From: Theodore Pagano, P.E., P.G. <tpagano@mipotash.com>  
Sent: Wednesday, November 04, 2015 12:58 PM  
To: Batka, Allan  
Subject: AOR  
Attachments: Class I AOR, further described 11-4-2015.pdf

The longitudinal AOR that you suggest is required for MPC 2D is in fact, already incorporated into the originally submitted AOR.

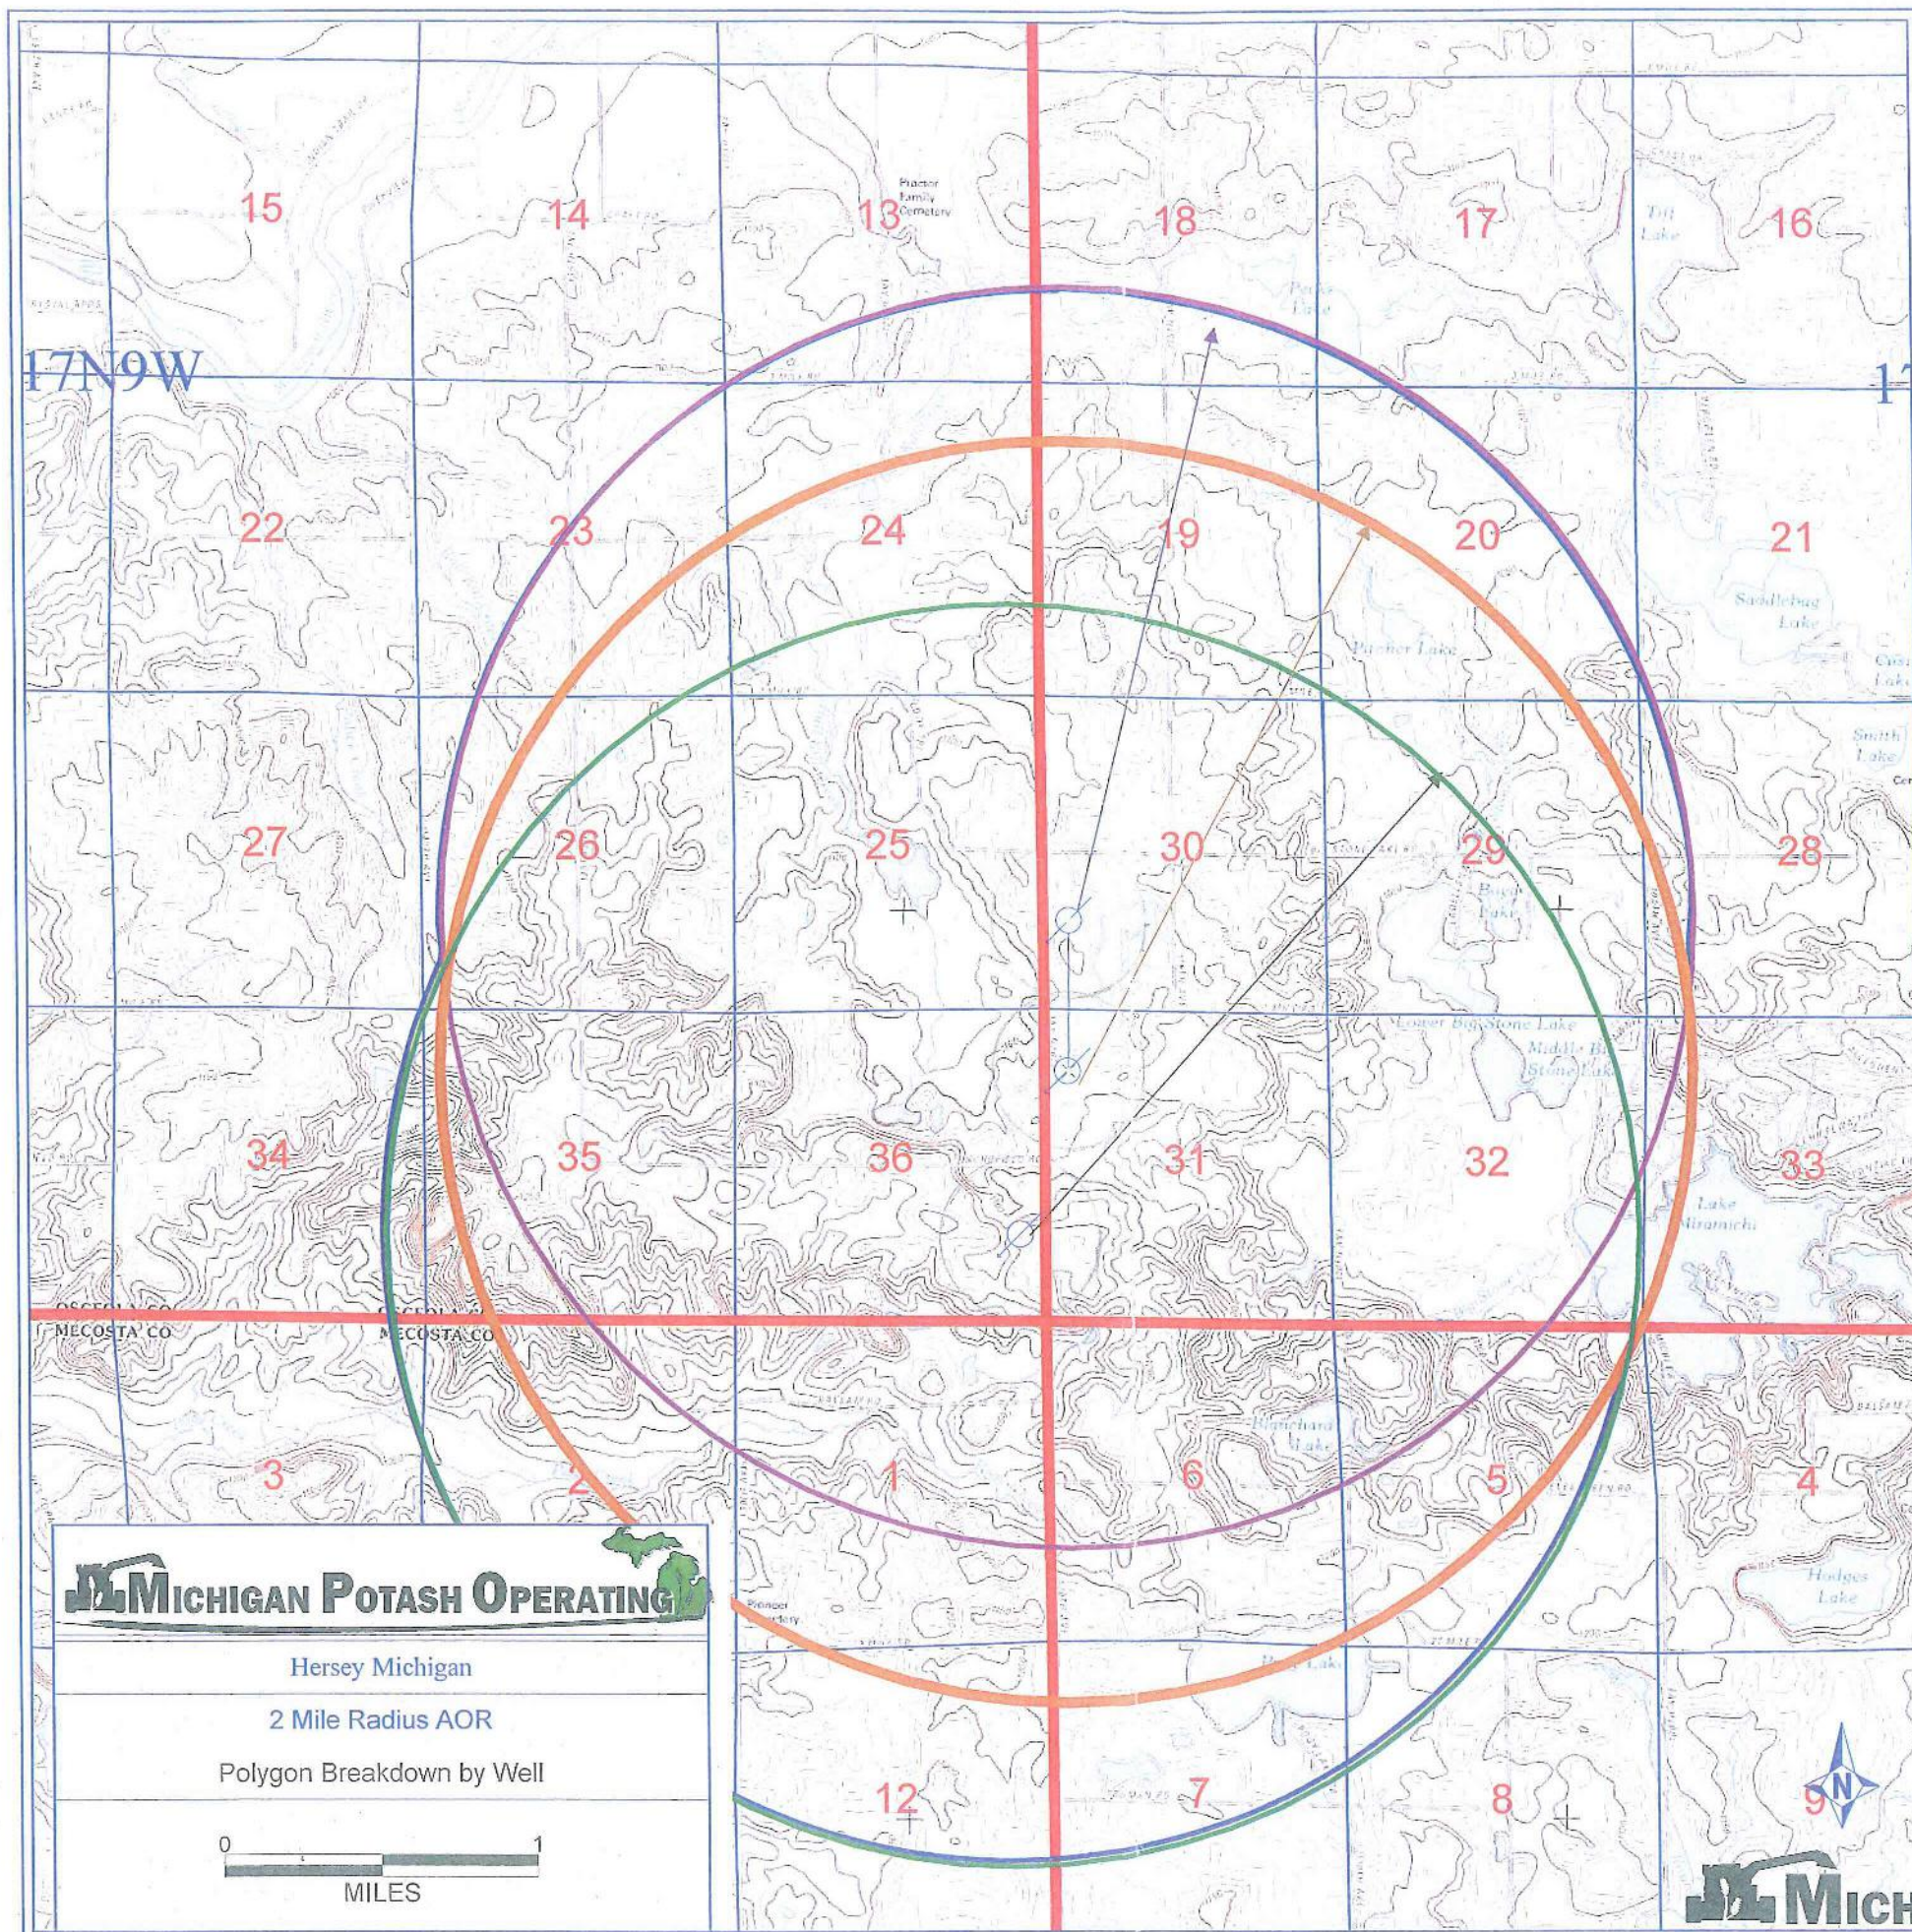
The longitudinal AOR that you suggest is required for MPC 2D is in fact, already incorporated into the originally submitted AOR.

All Exhibits and AOR considerations show Bottom Hole Locations and the Directional Path of the MPC 2D.

The MPC 1D and MPC 2D share the same surface location (Staked 20' apart), hence creating a longitudinal AOR as applicable to the MPC 2D.

All Wells have a 2 Mile Radius, creating the composite, irregular polygonal AOR as submitted in the original application.

The application AOR connects the arcs at the intersection points of all wells.
